Number: 01

Contract / *Burnt Store Road - Middle Segment*
Project
Name: *FPID 435422-1-54-01*

Description: *Adding new lighting from Sta. 1190+00 to Sta. 1321+00, on the east side of the north bound lanes and in the median, along the east side of the south bound lanes.*

Burnt Store Road - Lighting – Change Order

CONSTRUCTION CONTRACT NO.	FISCAL YEAR	SHEET NO.
	19	L-1

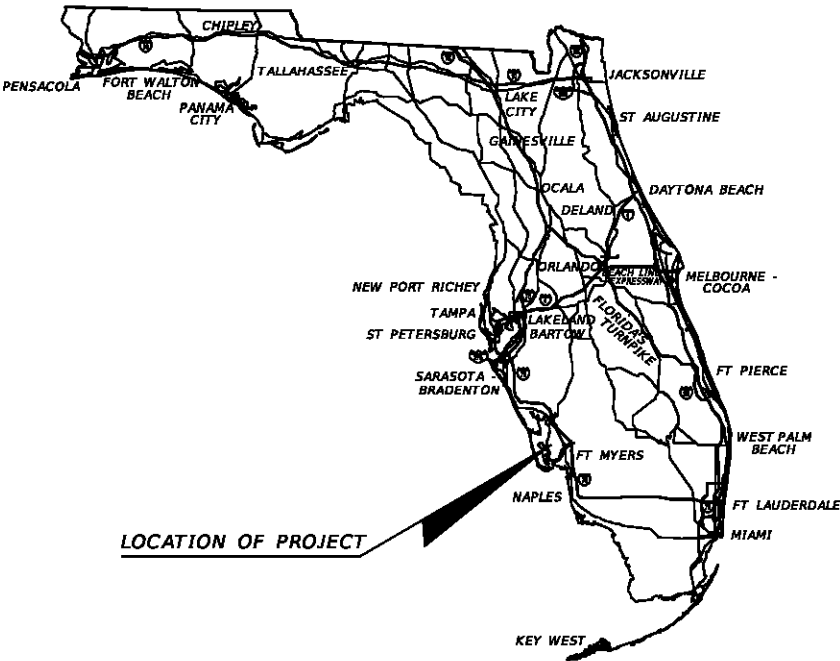
Note: Add interconnect for the length of project.
